Access Compliance Report

Public Rights-of-Way (Curb Ramps)

Intersection ID: N/A	Main Street: MARKLAND_DR	Cross Street: ELKMONT_PL	Location: SE
ADA ID: F0AACD56635C	Ramp Type: PerpDiag	Initial Pass/Fail: Fail	Overall Compliance: No
Severity Score: 8.75			
Codes/Mitigation Info/Possible Solution		Field Measurements/Component Compliance

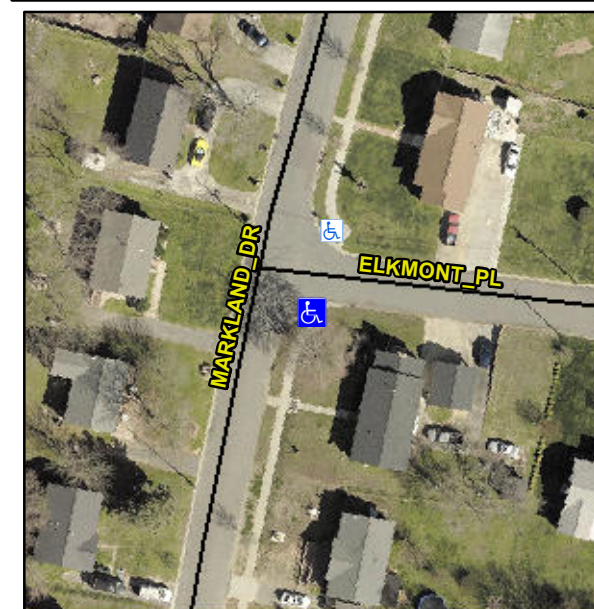
Not Found, R304.5.1

Compliance	Description	Data	Compliance	Description	Data
N/A	Ramp Length (in)	73.0	Yes	Ramp Slope (%)	6.4
No	Ramp Width (in)	47.0	Yes	Ramp XSlope (%)	0.2
N/A	Flare Type LT	N/A	N/A	Flare Type RT	N/A
N/A	Flare Slope LT (%)	N/A	N/A	Flare Slope RT (%)	N/A
N/A	Flare Traversable LT?	N/A	N/A	Flare Traversable RT?	N/A
N/A	Landing Length (in)	N/A	N/A	DWS Provided?	N/A
N/A	Landing Width (in)	N/A	N/A	DWS Contrast?	N/A
N/A	Landing Slope (%)	N/A	N/A	DWS Length (in)	N/A
N/A	Landing X Slope (%)	N/A	N/A	DWS Full Width?	N/A
N/A	Landing Curb? (Y/N)	N/A	N/A	DWS Offset (in)	N/A
N/A	Shared Landing?	N/A			
N/A	Gutter Ponding?	N/A	N/A	Gutter Slope (%)	N/A
N/A	Gutter Lip Ht (in)	N/A	N/A	Gutter X Slope (%)	N/A
N/A	Painted X Walk1?	No	N/A	Painted X Walk2?	No
	X Walk 1 Direction	To NE		X Walk 2 Direction	To W
N/A	X Walk 1 Width (in)	N/A	N/A	X Walk 2 Width (in)	N/A
	X Walk 1 Slope (%)	4.8		X Walk 2 Slope (%)	2.9
	X Walk 1 X Slope (%)	1.7		X Walk 2 X Slope (%)	3.0

Remove & Replace Curb Ramp With Two New Directional Ramps or Equivalent.
